Reviewer 1:

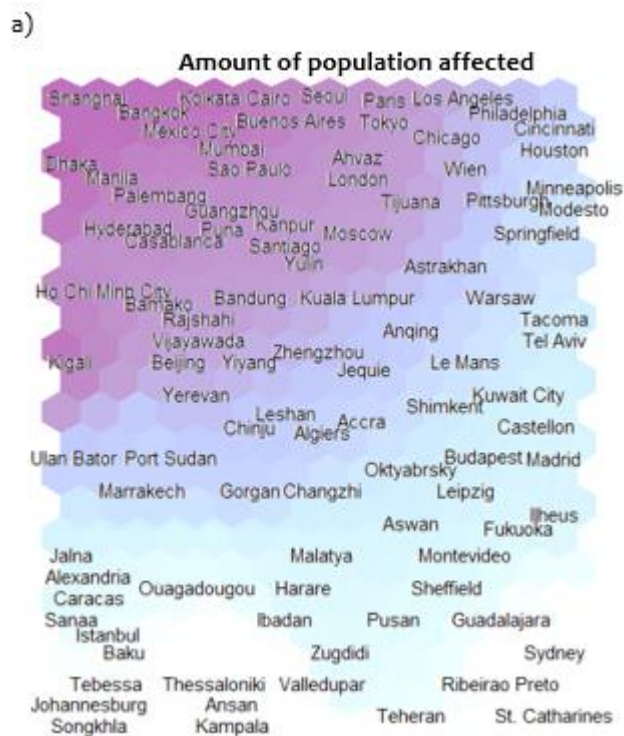
The data on the figures cannot be read in the pdf-version of the paper.

- Figures 1b), 2b), 3a) and 3b) have been reproduced with larger text, and the background colours have been lessened in intensity to make the text appear more clearly. We have tried a variety of text sizes on Figures 1a) and 2a), and believe the current text size makes it more clear precisely where each city is located on the map than a larger text size would. A note has been added to the caption referring the reader to the online version which can be zoomed in on. Figure b) maps with larger text could also be referred to if there is an issue reading the a) maps. The following is a screen shot of the pdf version of 1a), first at actual size, and then zoomed in. We believe both versions are readable.
